## Vibration and Deflection of Steel Bridges

Paper presented by RICHARD N. WRIGHT and WILLIAM H. WALKER (January 1972 issue)

Discussion by **THOMAS M. MURRAY**

Fig. 1. Domains of various strengths of sensations for standing persons subject to vertical vibration, adjusted for transient vibrations (after Reiher and Meister)

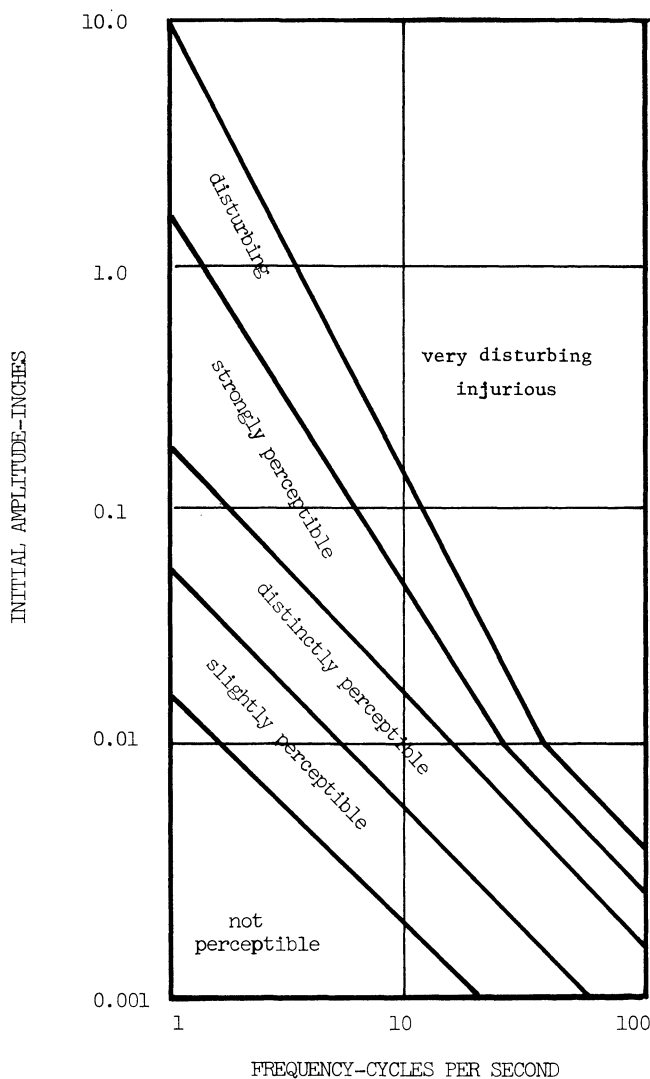
The set of curves presented by Reiher and Meister (see Ref. 2) and shown in Fig. 1 is the most frequently used criterion of human response to vertical structural movement. For transient vibration, the amplitude scale is multiplied by a factor of 10. Although Reiher and

Meister curves were developed using a limited number of subjects, the modified curves have been investigated on a number of different types of building floor systems by different researchers: Lenzen,<sup>2</sup> steel joint-concrete slab systems; Lenzen and Murray,<sup>3</sup> steel beam-concrete slab systems; Polensek<sup>4</sup> wood joist systems; Commonwealth Experimental Building Station,<sup>5</sup> various systems.

Based on the above investigations and on extensive literature review on human response to structure-borne vibrations,<sup>6</sup> this discussor recommends the use of the Reiher-Meister curves until a badly needed research program is undertaken to more accurately define human response to vibration.
